Intel[®] Pentium[®] III Xeon[™] Processor Specification Update

Release Date: May 2000

Order Number: 244460-015

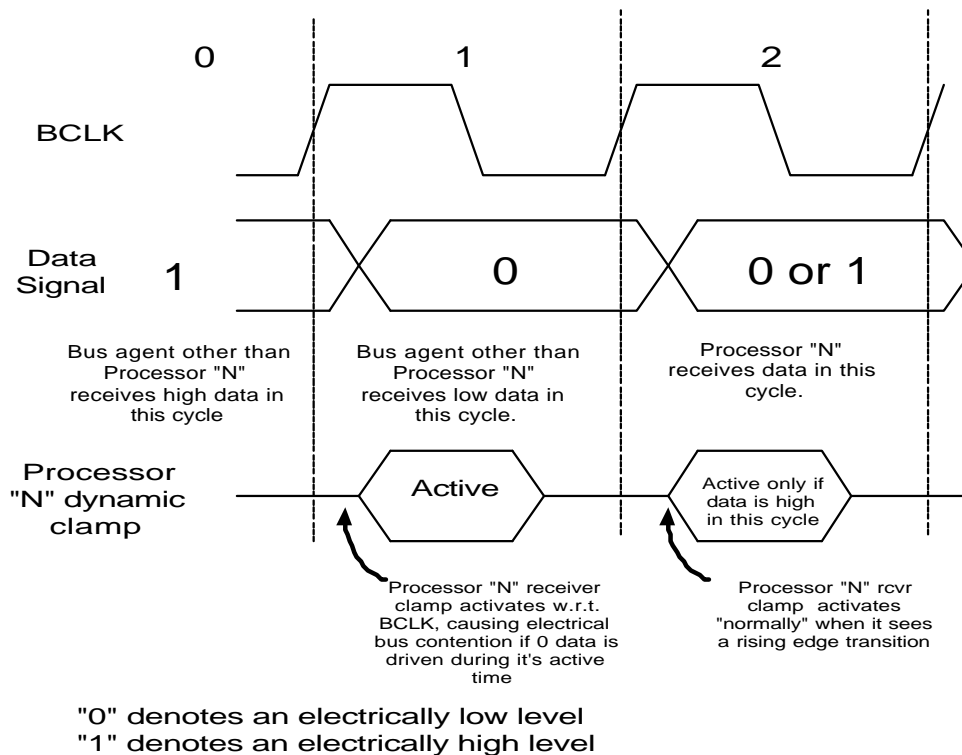
Workaround: The AGTL+ V_{REF} (input voltage reference) level will be raised from 1.0V to 1.1V (assuming a V_{TT} of 1.5V) on the processor cartridge substrate. This allows the dynamic clamp to activate at a trigger level approximately 100 mV higher than with the previous 1.0V V_{REF} setting. Due to the dependence upon system bus design, bus layout may be evaluated to determine the need for improvements in falling edge ringback levels. This may involve one or several of the following baseboard modifications:

1. Change termination resistor value to reduce multi-bit noise and/or improve V_{IL} noise margin.
2. Reduce multi-bit noise by improving ground return paths (additional high-frequency decoupling, improved AC plane referencing, etc.).
3. Raising or lowering the V_{TT} level (within the AC & DC tolerances specified in the processor EMTS) to improve V_{IL} noise margin and/or reduce the multi-bit noise due to di/dt transients.
